Planning & Zoning Board

Thursday, September 21, 2023

1. App# 2023-5479; 1551 Ives Avenue; Marie's House of Hope Inc.; Conditional Use
2. App# 2023-5486; 7305 E. Main Street; Richard Holmes; Variance
3. App# 2023-5487; 7305 E. Main Street; Richard Holmes; Certificate of Appropriateness

**MINUTES REGULAR MEETING
REYNOLDSBURG PLANNING & ZONING BOARD
September 7, 2023**

DATE:
01/16/23

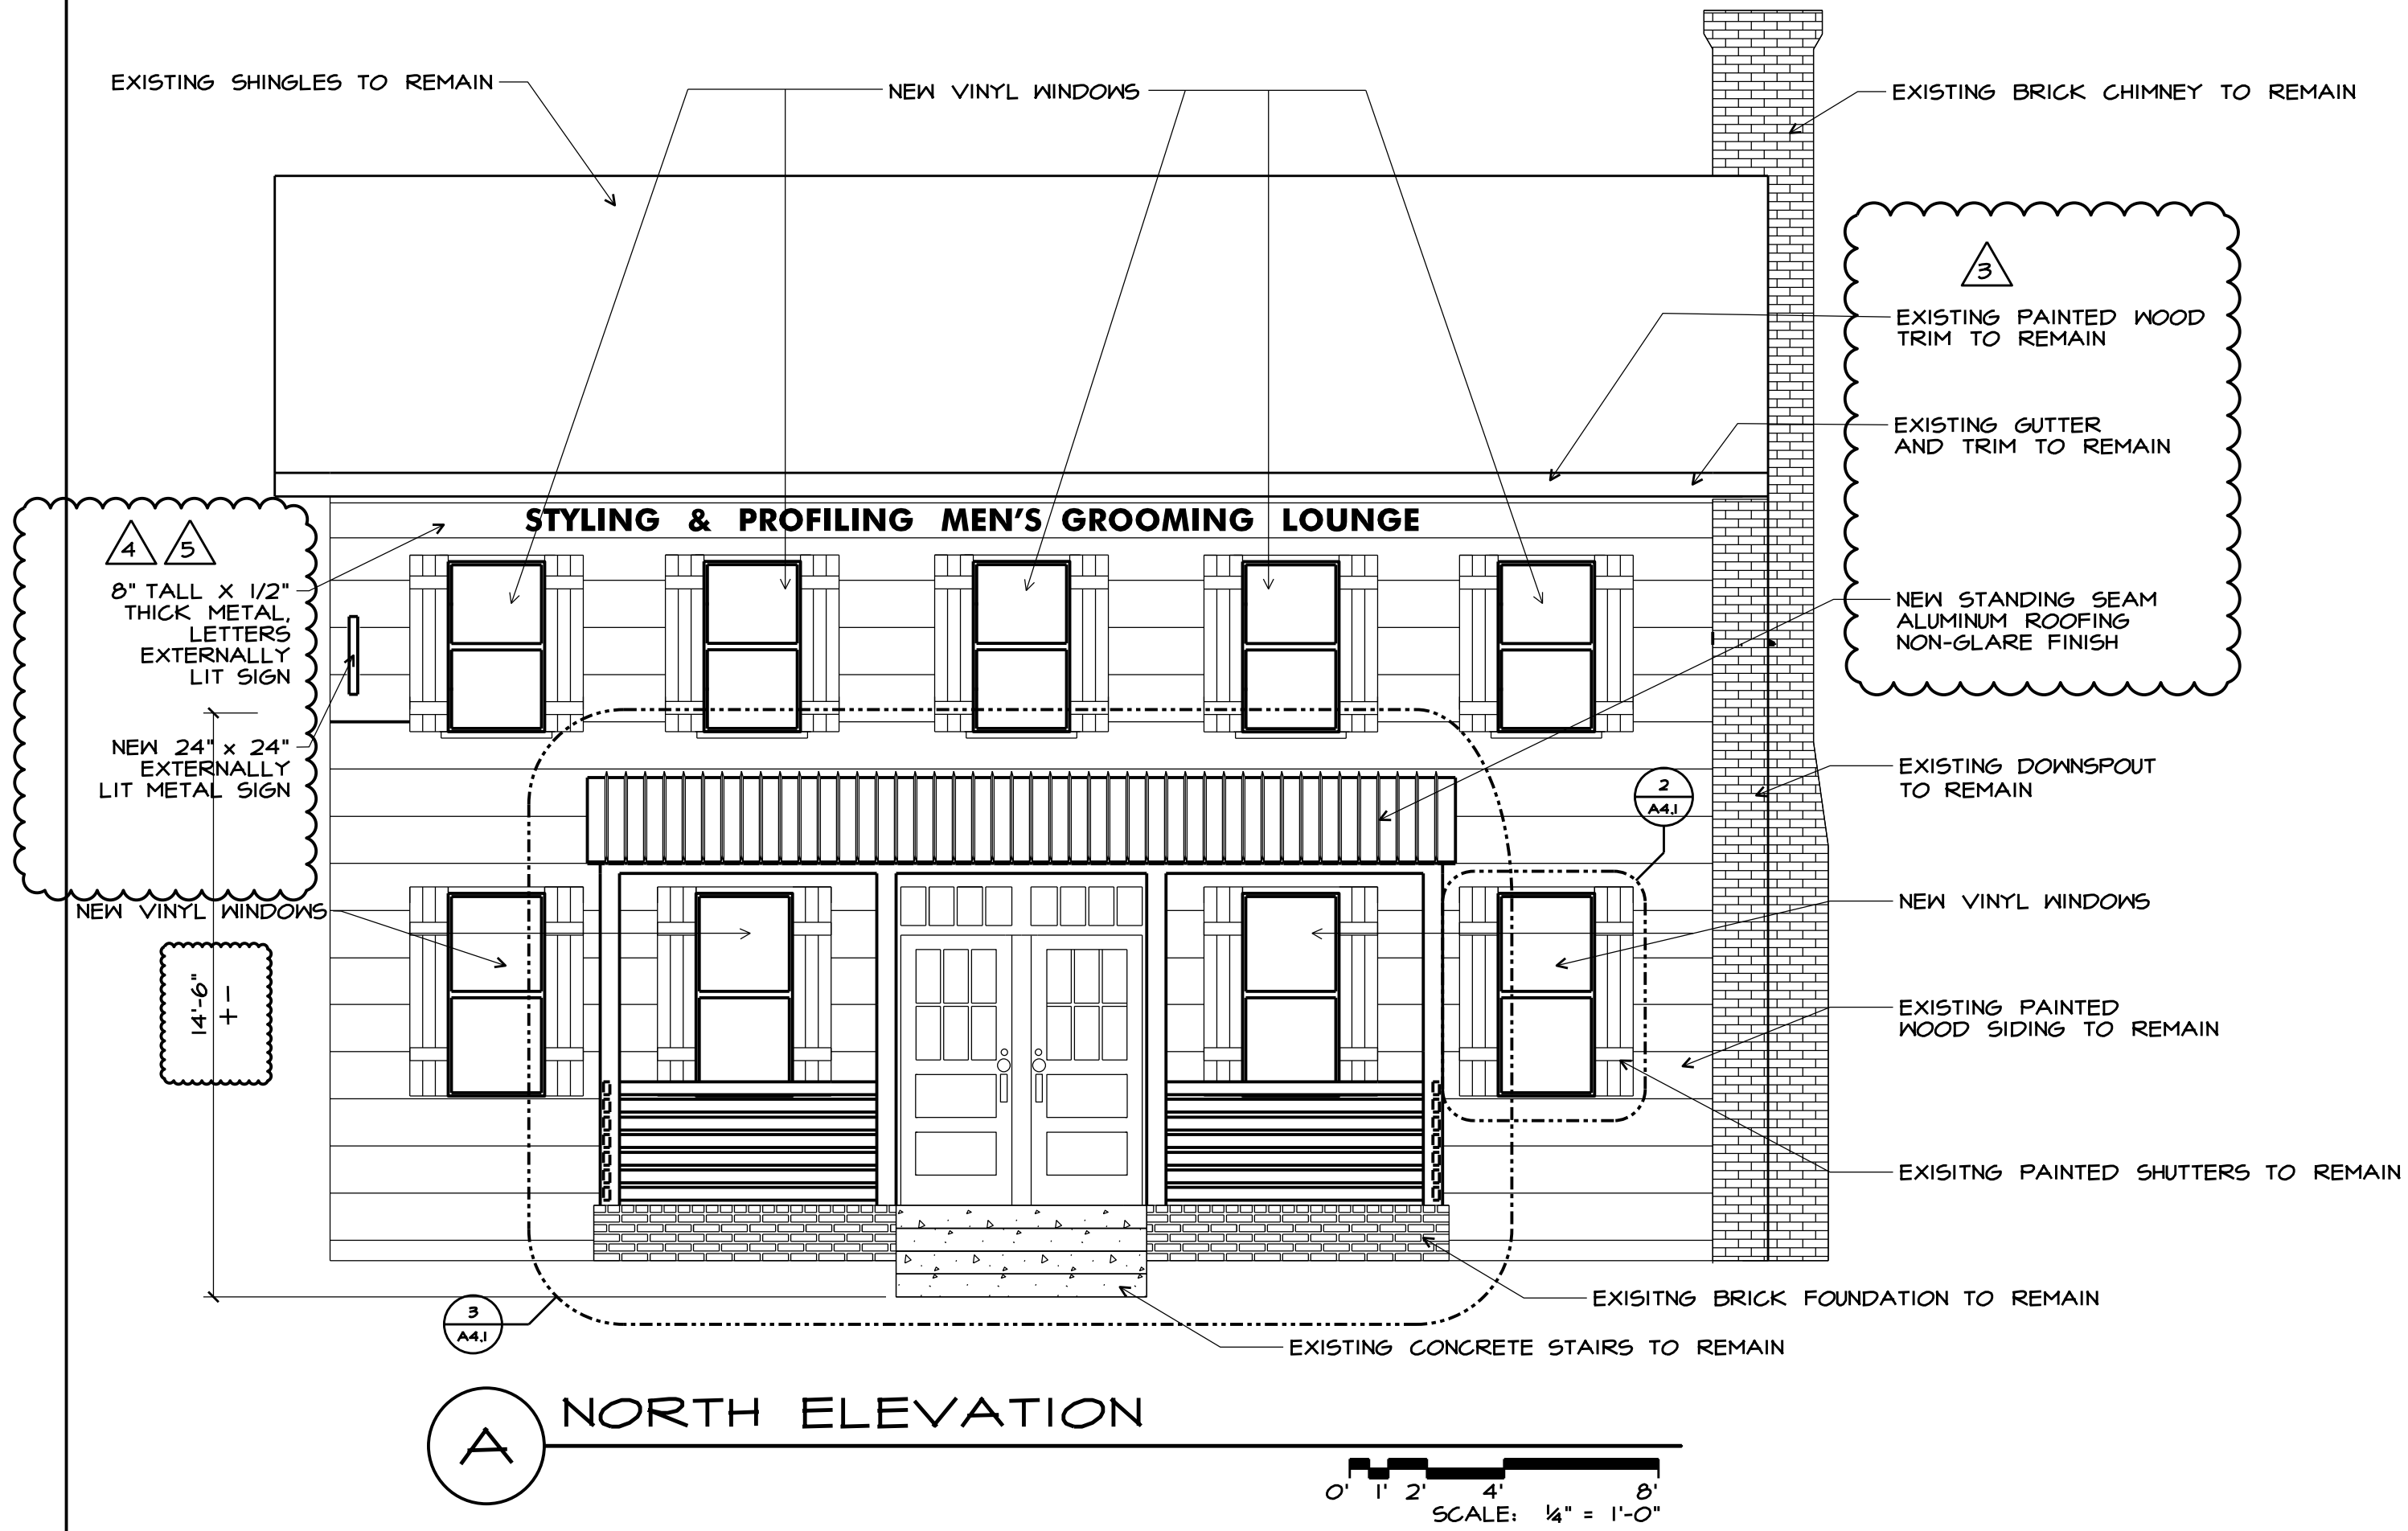
- a. No Plan B. Not provided on A-1.1. Not angled out on the sheets, needs to be clearly identified.
10. The sign plan states the sign is 48" by 48" for a total square footage of 16SF. The maximum square footage permitted of a projecting sign is 6 SF. Section 1105.03.C.v.2

- vii. Since the architectural drawings (Sheet A1.1) show the new porch overhang over the property line, into the public right-of-way, please provide a hold-harmless agreement with the City. Please have the City Attorney’s office deem the agreement sufficient, prior to a Certificate of Appropriateness being issued.

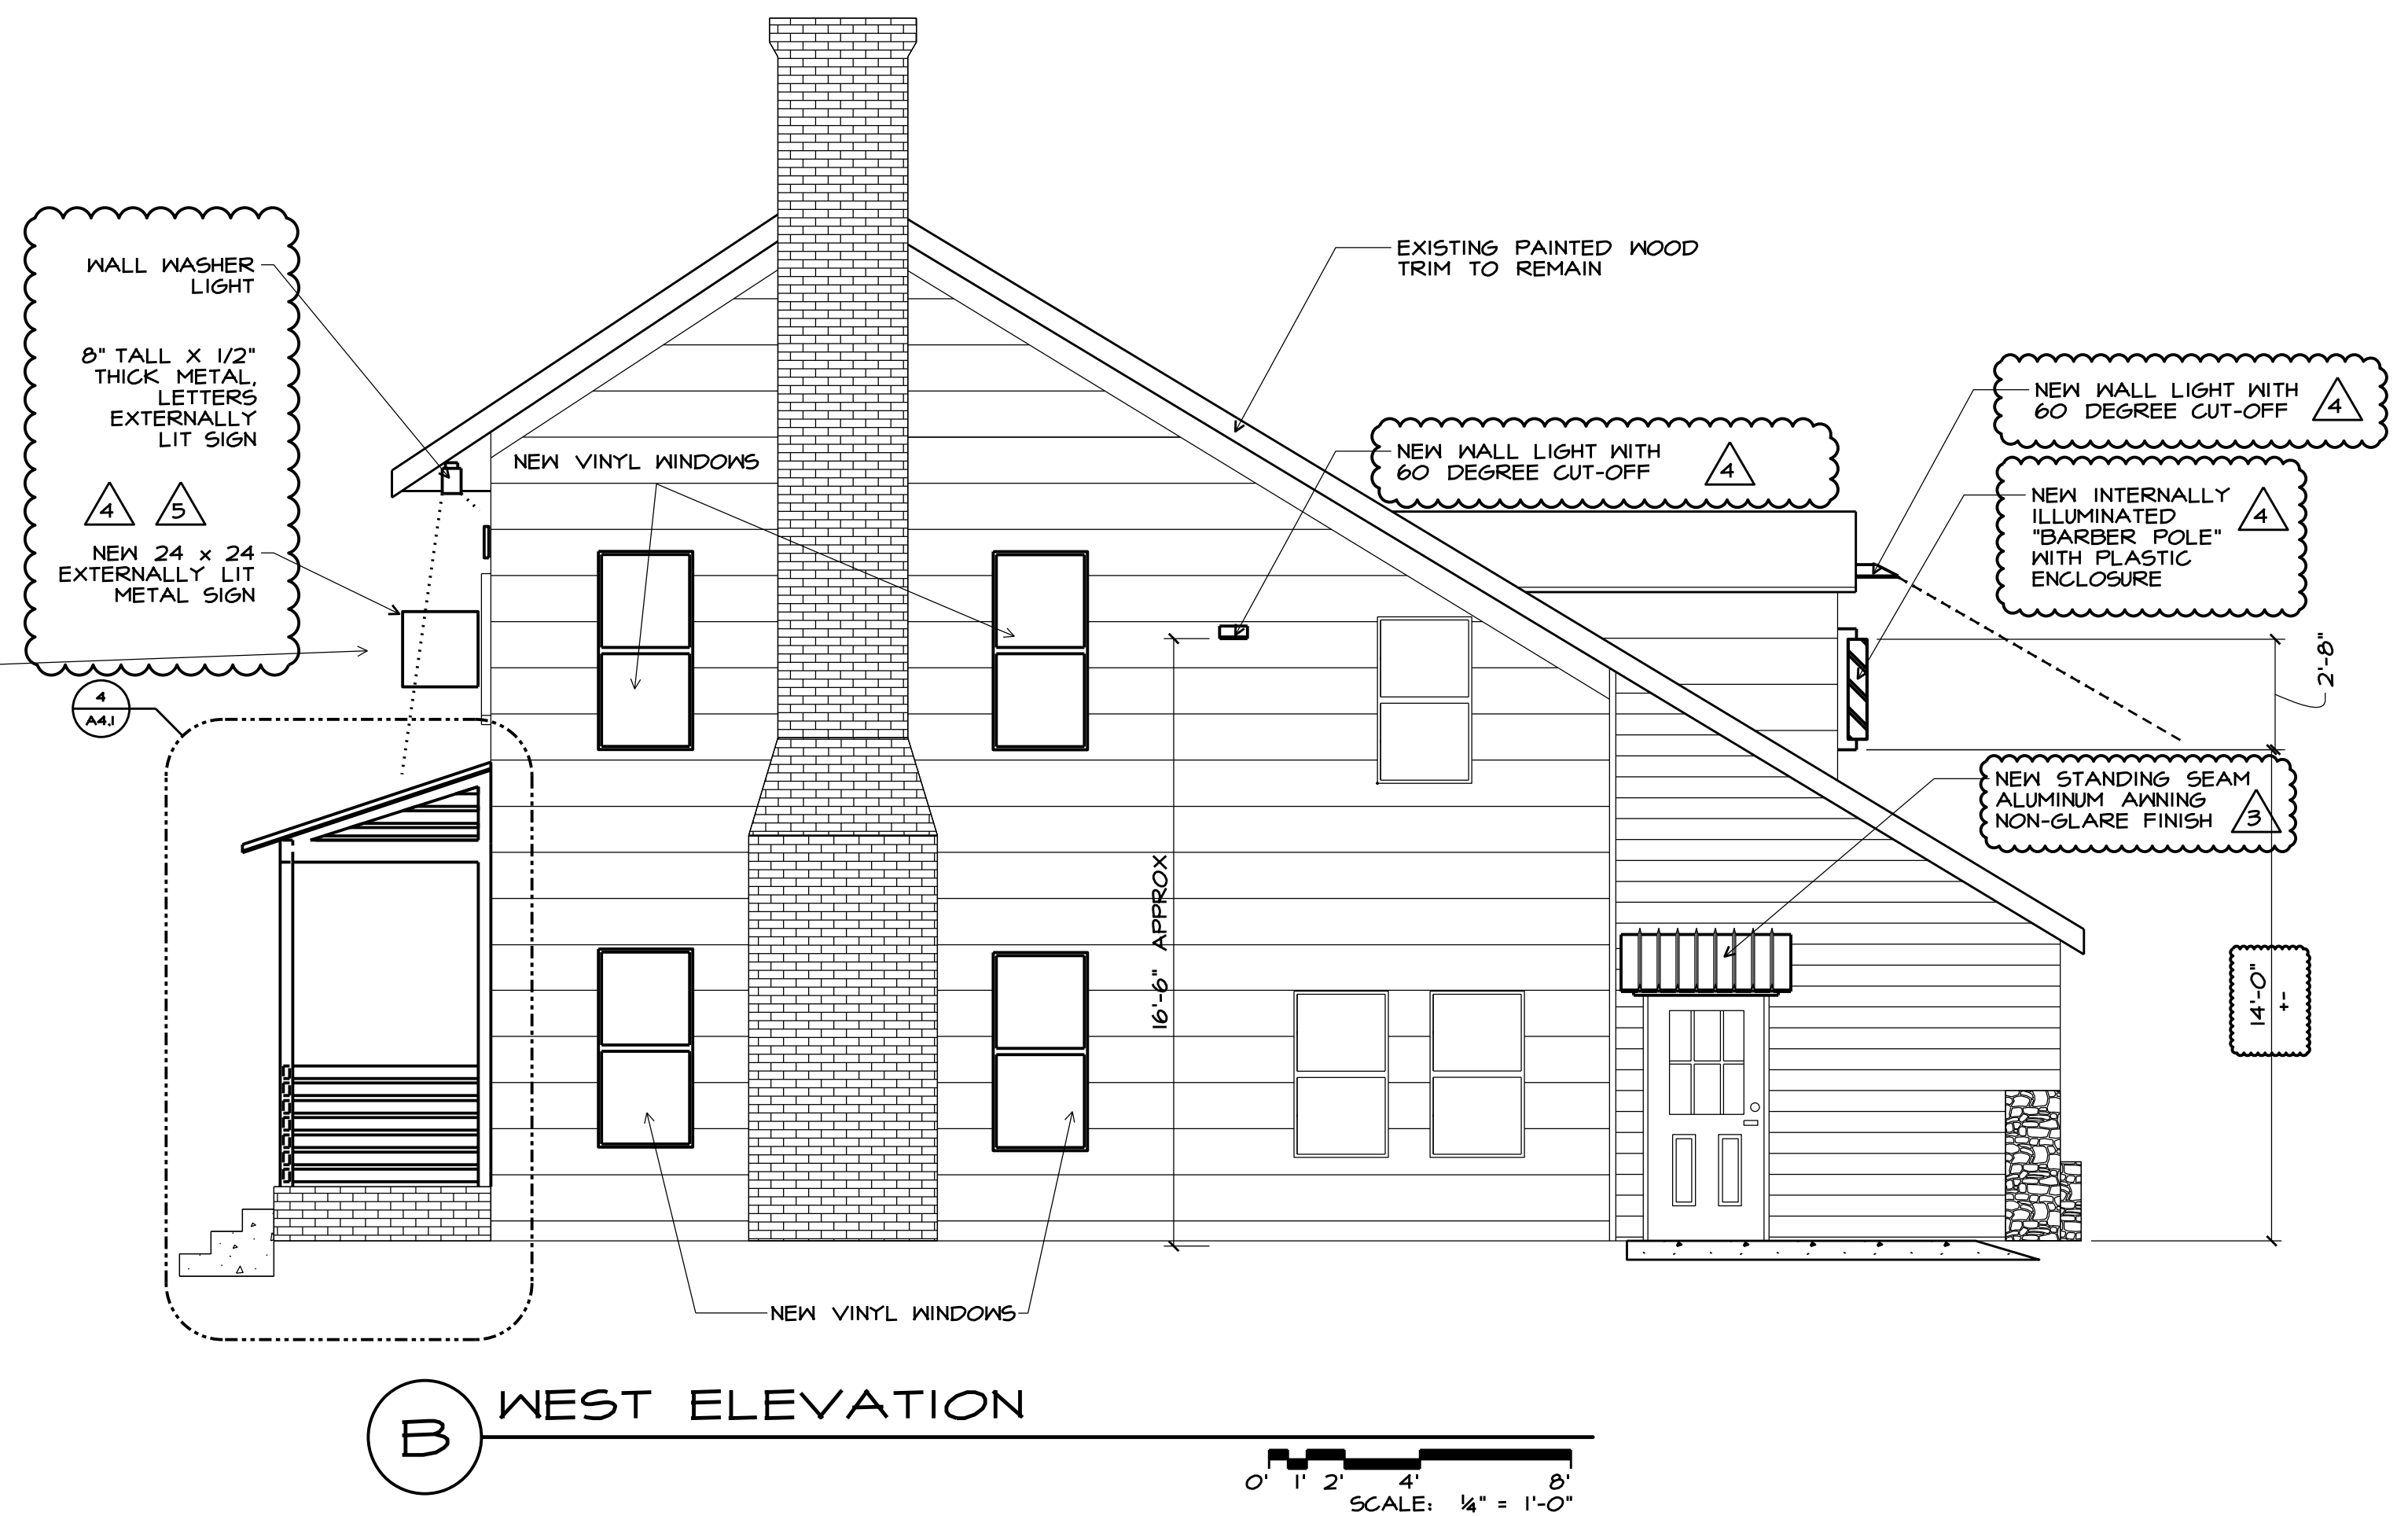
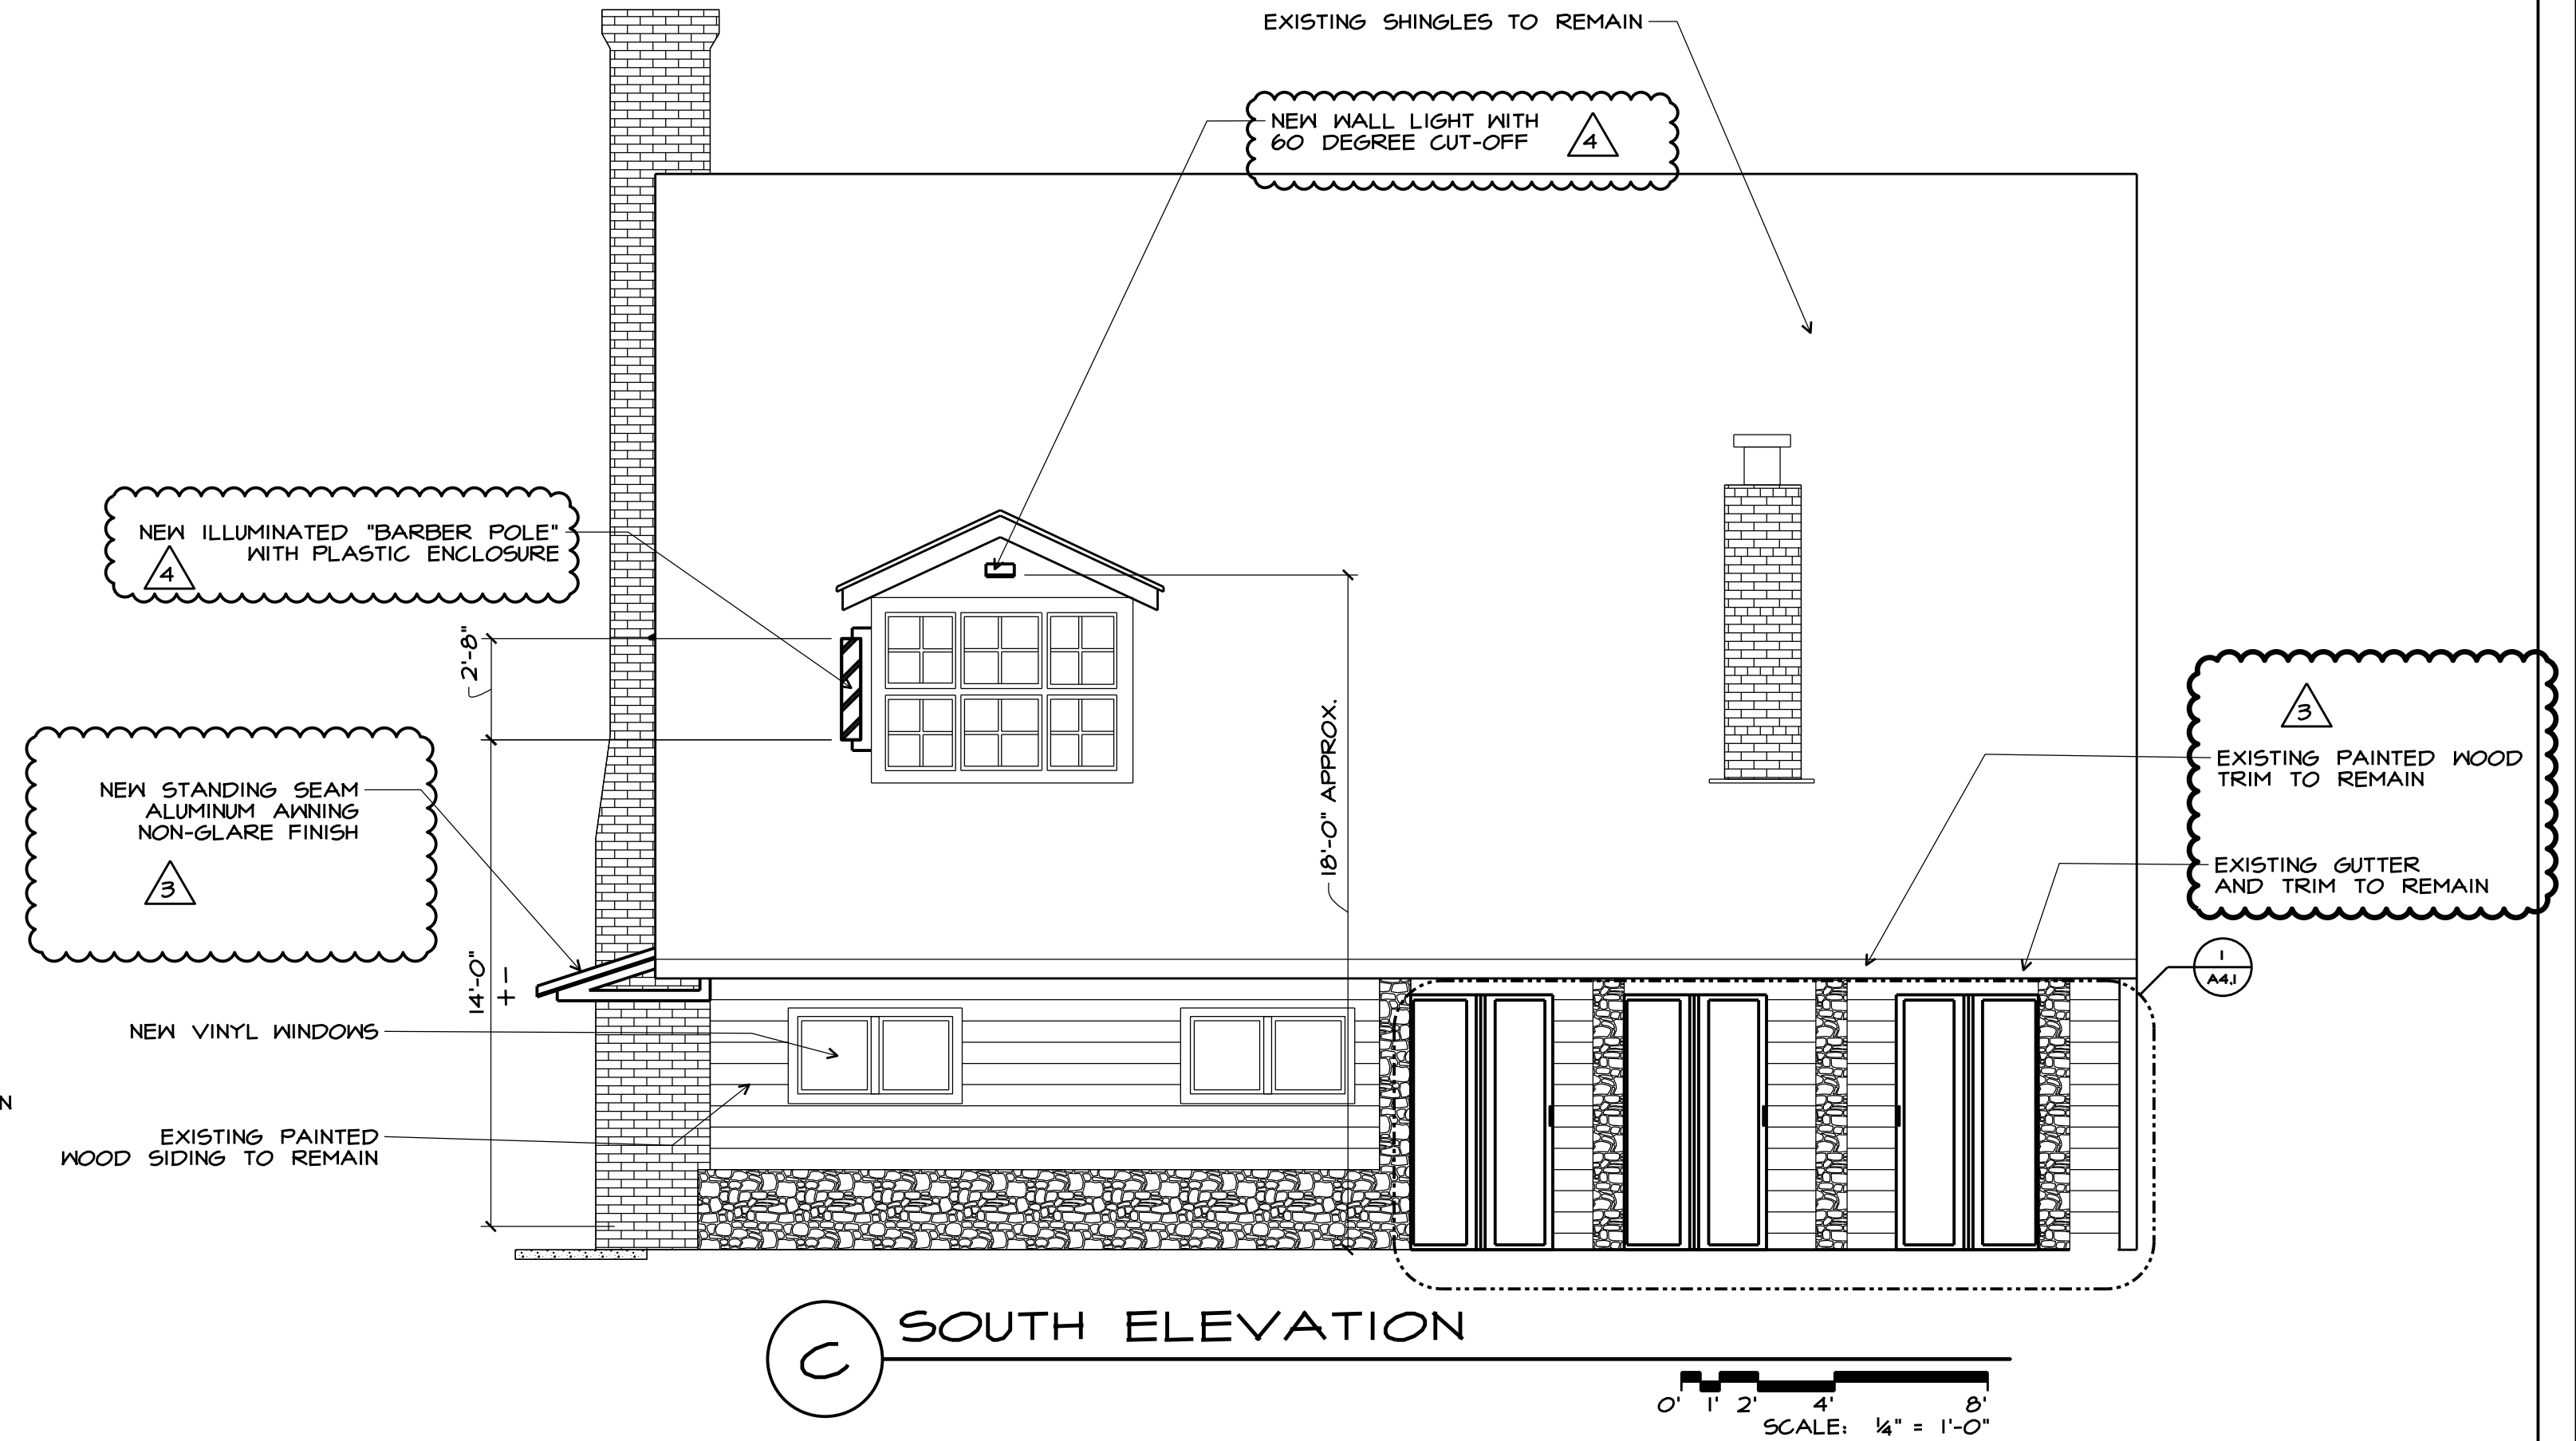
- a. No Plan B. Not provided on A-1.1. Not angled out on the sheets, needs to be clearly identified.
10. The sign plan states the sign is 48" by 48" for a total square footage of 16SF. The maximum square footage permitted of a projecting sign is 6 SF. Section 1105.03.C.v.2
